City of Alexandria, Virginia

MEMORANDUM

SUBJECT: DSUP # 2011-0015 – SAFEWAY REDEVELOPMENT - TOPICS FOR ADDITIONAL DISCUSSION

Re: Safeway located at Braddock and King
Site Plan with eliminated access point.

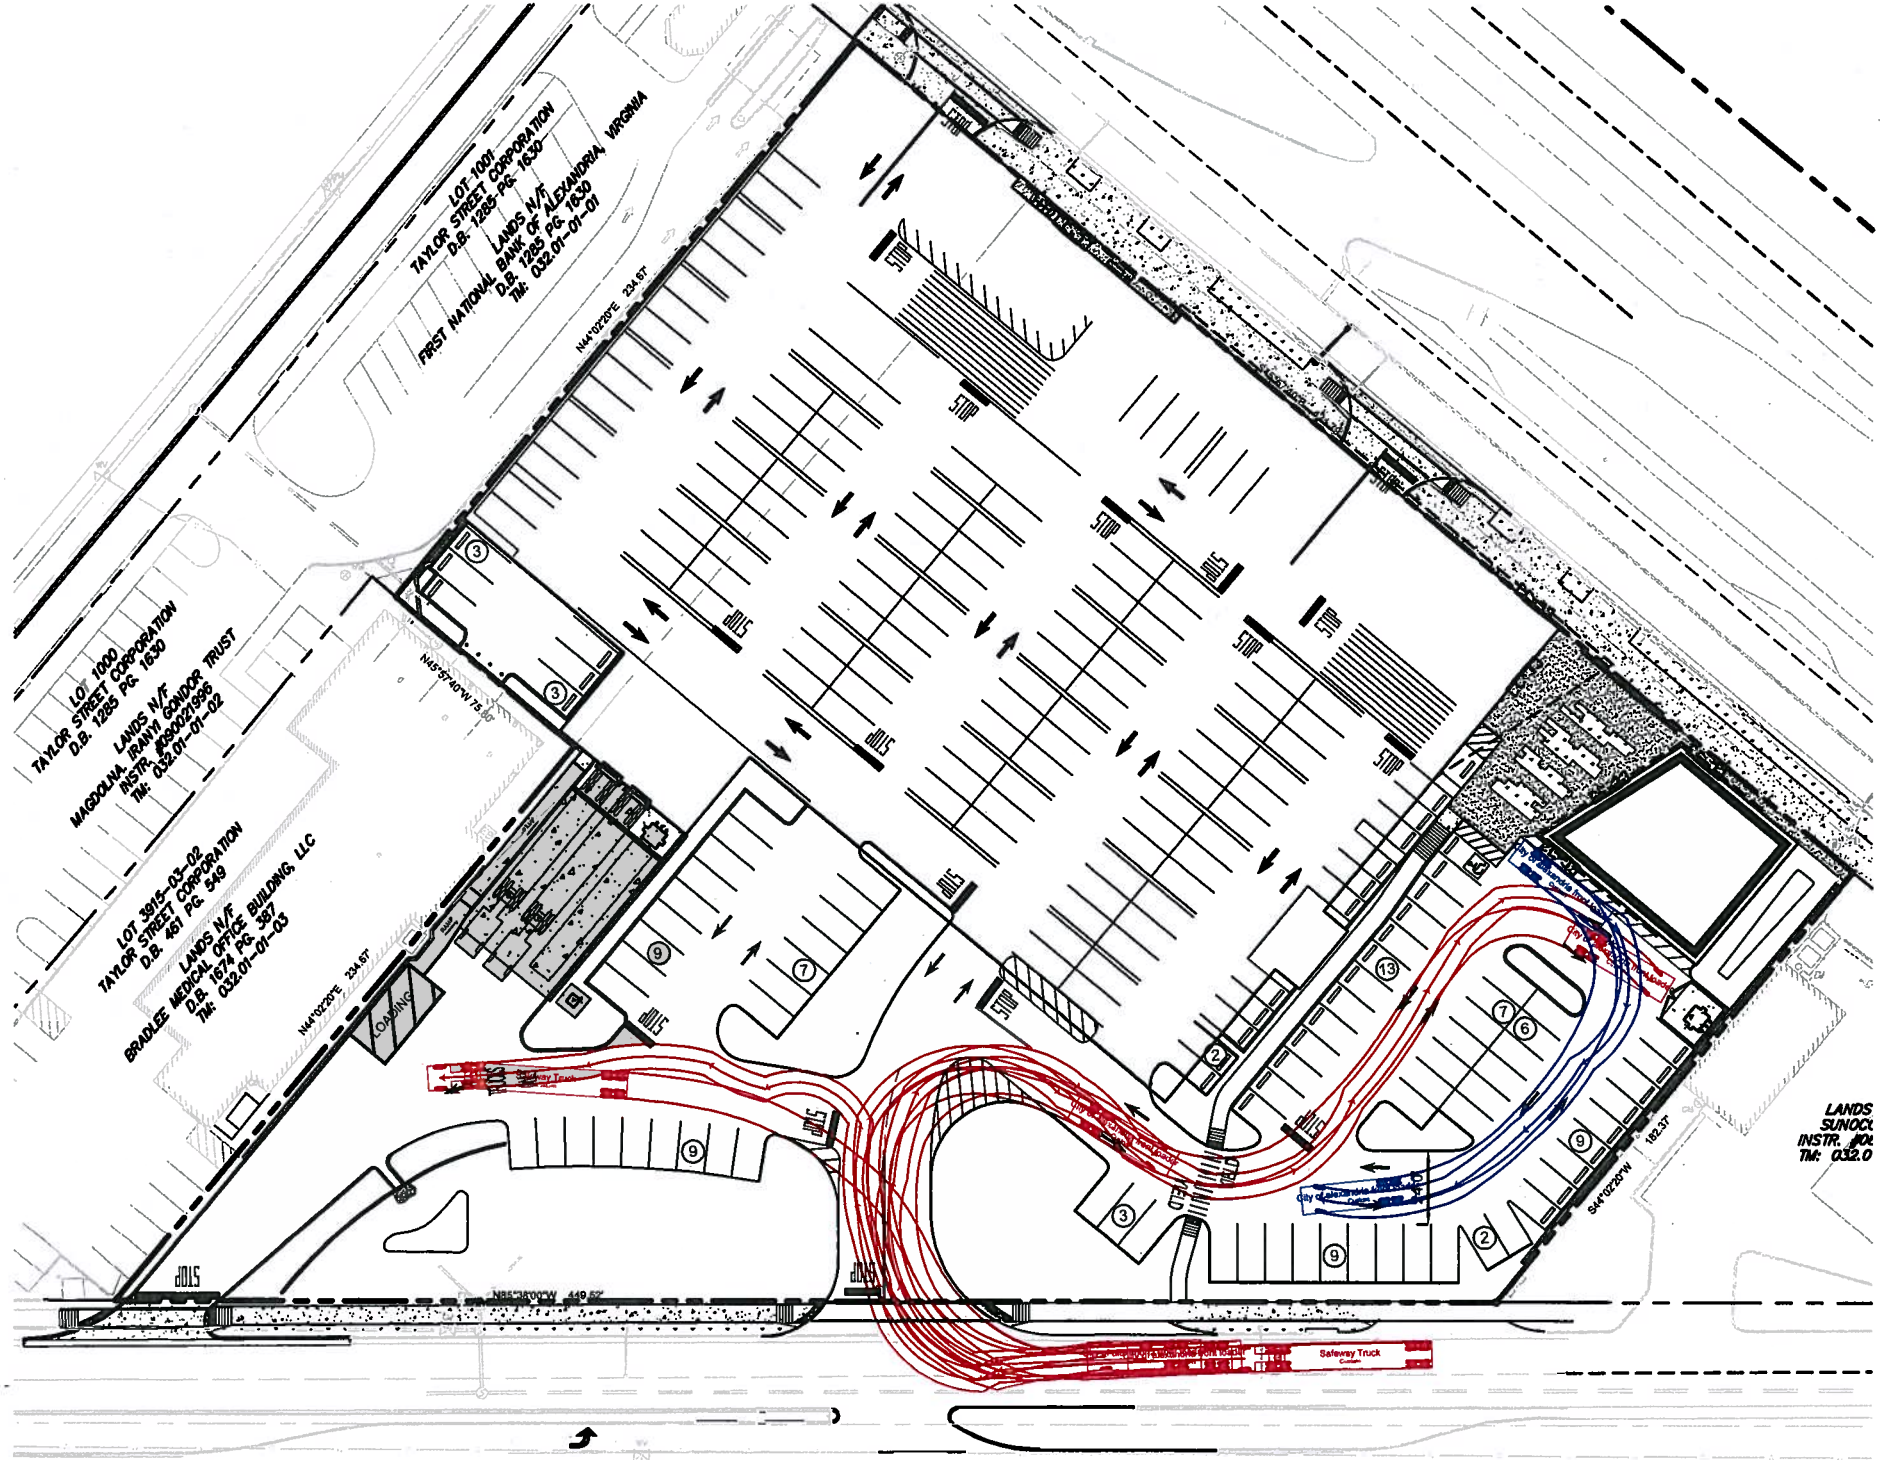
The City requested that the Safeway design team re-evaluate the site plan layout if the easternmost access point onto Braddock Road was eliminated. *It should be noted that the current plan has already effectively eliminated one of the three existing curb cuts as presently designed.* The westernmost access point has been modified from a right-in / right-out driveway to an exit only to be used exclusively for existing delivery trucks. The driveway has been designed to intersect Braddock Ave at an angle which will prevent vehicles from entering the site. The interior driveway will be signed to prevent cars from using the driveway to exit the site. We anticipate a maximum of only 20 to 25 delivery trucks using that exiting driveway per day. During the initial design process, the City requested us to perform a similar evaluation which determined that all three curb cuts were needed in order for the site to function efficiently and safely.

During this requested re-evaluation, we looked at a number of site plan options, with the attached site plan concept being the best of those options. We have a number of concerns related to the impacts on the site, which are summarized below:

Parking – The current plan that was presented to the Planning Commission on November 2nd provided for a total of 229 parking spaces to be shared between the Safeway grocery store and the small retail building. The parking ratio for that plan was 3.65 parking spaces per 1,000 sf of net building area. The concept plan that is attached results in 15 parking spaces being eliminated. The reduction of parking reduces the parking ratio to 3.41 spaces per 1,000 sf. The site cannot afford to eliminate any parking spaces.

Pedestrian Access – The current plan reduces the number of access points from two to one. While typically fewer curb cuts is beneficial for pedestrians, we believe the entire pedestrian realm and all site constraints must be considered before making such a determination. On the

surface closing a curb cut would appear to be beneficial for pedestrians needing to pass by the site since the number of conflicts is reduced. However, with two access points, the number of cars entering and leaving the site is split between the two driveways, which increases the amount of time between cars entering and exiting the driveways. Under the current plan, there are two driveways, a western driveway and an eastern driveway. Based on the planned

Based on the increase in the number of cars at a single driveway, we feel that there is a potential for more vehicular/pedestrian conflicts which will have a negative impact on pedestrian safety at the site along Braddock Road.

The center full access driveway on Braddock must provide the inbound for trucks, the inbound for eastbound Braddock Road traffic and the outbound for patrons needing to go east on Braddock Road. Other movements have options that go away if the easternmost curb cut under consideration is closed. Without it, all traffic on the Braddock Road side of the site must enter and exit through the one driveway. This will increase the potential for congestion and the likelihood that any such congestion could lead to traffic queuing back into Braddock Road which is undesirable. Therefore, the best option is to maintain the easternmost curb cut.

The city's department of Transportation and Environmental Services (T&ES) reviewed the analysis and agrees with the applicant's conclusion that the benefits of elimination of the easternmost site access point on Braddock Road are outweighed by the drawbacks, especially the reduction in on-site parking. T&ES supports the applicant's recommendation to maintain three curb cuts on Braddock Road; however, to enhance the pedestrian experience, T&ES recommends widening the sidewalk along Braddock Road to 8', with dedication of right-of-way by the applicant in areas where the 8' sidewalk would encroach onto the applicant's site. Another recommended way of minimizing pedestrian/vehicular conflict is to restrict the most western entrance to right out only and restrict the use to the service and delivery vehicles. Staff is recommending that signage be installed to implement these restrictions.

Exhibit A

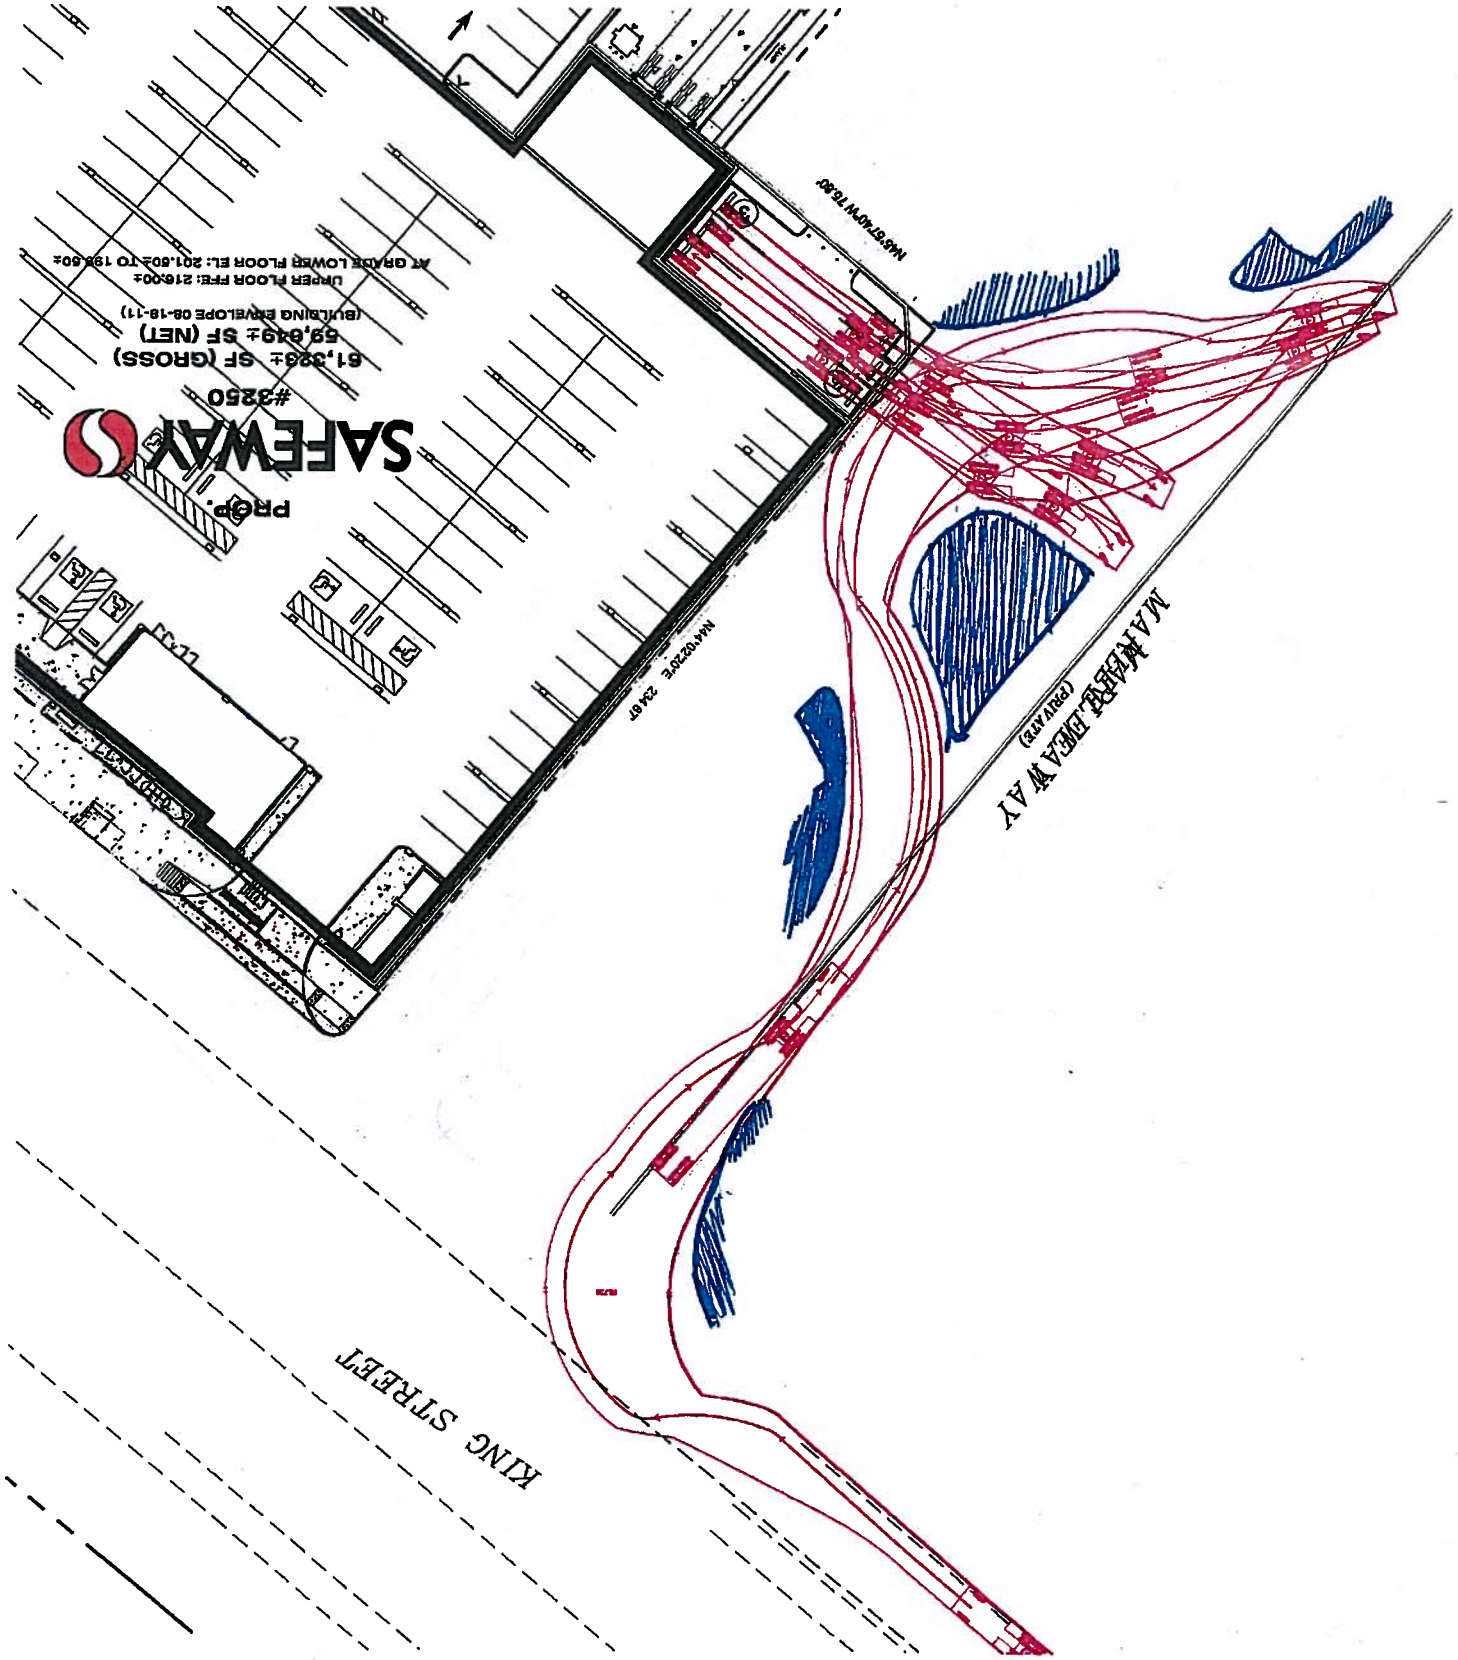
Configuration #1 (exhibit A) – We were asked to evaluate if a delivery truck could access the site from Marlee Way. We modeled the truck path using an AASHTO WB-67 delivery truck using Autoturn Software. The truck was modeled travelling eastbound on the King Street service road, and turning onto Marlee Way. The trucks then pull into the Suntrust and Medical Office parking areas, pull forward to Marlee Way, and back up into the truck loading dock and exit using the same path.

This configuration presented a number of challenges:

1) Safeway does not own or have control of the Suntrust and Medical Office properties.
2) The two property owners do not have an interest in granting an access easement.
3) The truck movements would result in a large loss of parking spaces on the Suntrust and Medical office lots.
4) The truck travelling on the service road would have to travel into oncoming traffic to make the turn onto Marlee Way.
5) The existing radius at the Marlee Way and service road is not large enough to accommodate truck traffic
6) Marlee Way is only a 20 foot wide roadway, and potentially not designed for truck traffic.
7) Truck turning movements would impact drive lane queuing depth for the Suntrust drive thru.

8) There is no available area for staging of delivery trucks and for loading/unloading of smaller local delivery.
9) Truck turning movements create a number of unsafe pedestrian and vehicular conflicts.

The city's department of Transportation and Environmental Services (T&ES) acknowledges the applicant's statement that neither the SunTrust nor Medical Office properties have an interest in granting an easement to the applicant and that the option to relocate the loading dock to Marlee Way is not feasible. Even if an easement were to be obtained, there are significant geometric limitations associated with Marlee Way that would require substantial modifications and improvements to make Marlee Way a viable truck route. Staff also agrees the applicant's additional analysis that truck access from the service road and reorienting the loading area would eliminate additional parking, reduce the bio-retention area and potentially create an unsafe situation.

Exhibit B

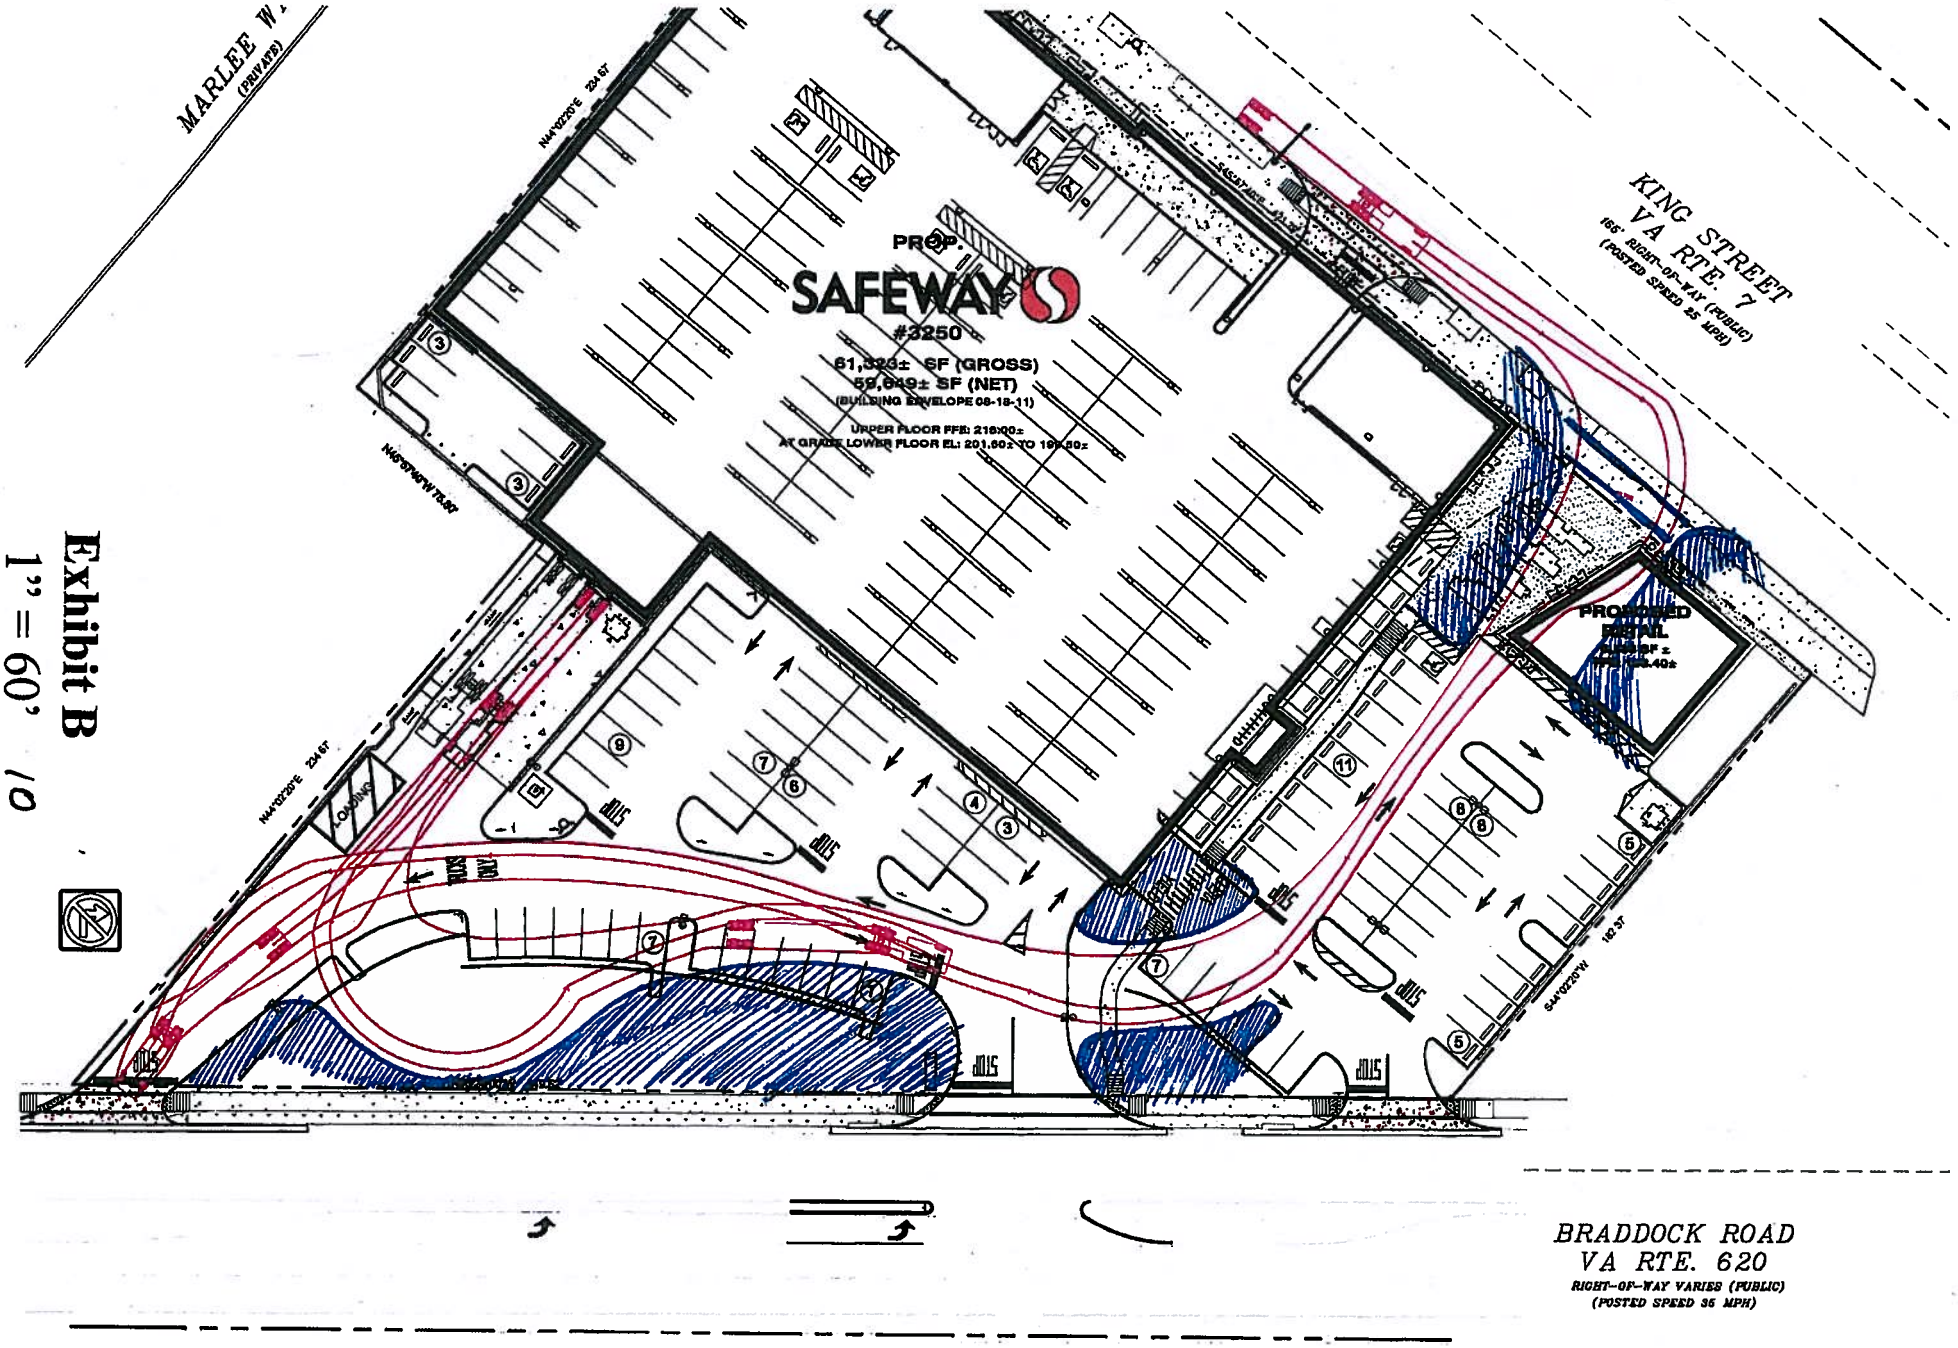
Configuration #2 (exhibit B) – We were asked to evaluate if a delivery truck could access the site from the service road, to avoid trucks travelling on Braddock Way. We modeled this path using an AASHTO WB-67 delivery truck using Autoturn Software. The truck was modeled travelling eastbound on the King Street service road, and turning into the site. The truck would negotiate through the parking area and into the loading dock. The trucks would then leave the loading dock and exit in the same path back to the service road.

This configuration presented a number of challenges:

1) The new path would require removal of the proposed retail building and/or the bio-retention area.
2) The new access point would eliminate the pedestrian plaza located along King Street.

3) The new access point would create a new crosswalk along the service street, increasing the number of conflict points with vehicles and pedestrians.
4) The new access point would sever the connection between the Safeway grocery store and the retail/pedestrian area.

5) The delivery trucks would have to travel through parking and pedestrian areas, while the current design tries to separate delivery trucks and patron parking areas.

6) The travel path of the truck requires the driver to pass through the main access on Braddock.
7) The truck path for the exiting truck requires the elimination of the majority of the bio-retention areas.

8) The proposed configuration removes approximately 19 parking spaces and increases the amount of impervious area.
